Contract #: 04-0120F4Cty: SF/ALA Rte: 80 PM: 13.2/13.9File #: 1.28**WELDING INSPECTION REPORT****Resident Engineer:**Siegenthaler, Peter**Address:** 333 Burma Road**City:** Oakland, CA 94607**Report No:** WIR-023232**Date Inspected:** 29-Apr-2011**Project Name:** SAS Superstructure**OSM Arrival Time:** 700**Prime Contractor:** American Bridge/Fluor Enterprises, a JV**OSM Departure Time:** 1530**Contractor:** American Bridge/Fluor Enterprises, a JV**Location:** Job Site**CWI Name:** Steve Jensen**CWI Present:** Yes No**Inspected CWI report:** Yes No N/A**Rod Oven in Use:** Yes No N/A**Electrode to specification:** Yes No N/A**Weld Procedures Followed:** Yes No N/A**Qualified Welders:** Yes No N/A**Verified Joint Fit-up:** Yes No N/A**Approved Drawings:** Yes No N/A**Approved WPS:** Yes No N/A**Delayed / Cancelled:** Yes No N/A**Bridge No:** 34-0006**Component:** SAS Tower**Summary of Items Observed:**

# WELDING INSPECTION REPORT

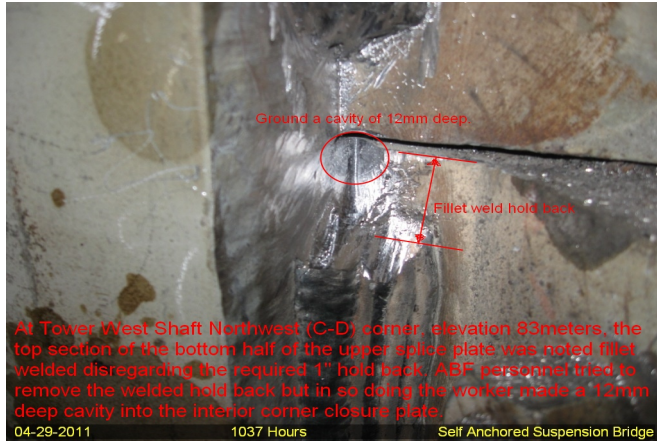
At Tower West Shaft Splice #2 @Elevation 83meters:

At the request of Quality Control Field Supervisor, Bonifacio Daquinag, QA has randomly verified the QC VT of the fillet welded lower and upper splice plate joints. During the QA verification, the following observations were noted;

1. At Northwest (C-D) corner of upper splice plate, the top section of the bottom half vertical fillet on two sides of the plate were fillet welded disregarding 1" hold back before the interior closure plate splice.
2. ABF QC Steve Jensen has visually accepted the welded 1" hold back disregarding this same specific requirement.
3. ABF personnel have tried to grind off the welded hold back but in so doing they ground excessively into the interior closure plate leaving a cavity of at least 12mm deep.

Due to the above infractions that were observed during the VT verification, an Incident Report will be forthcoming.
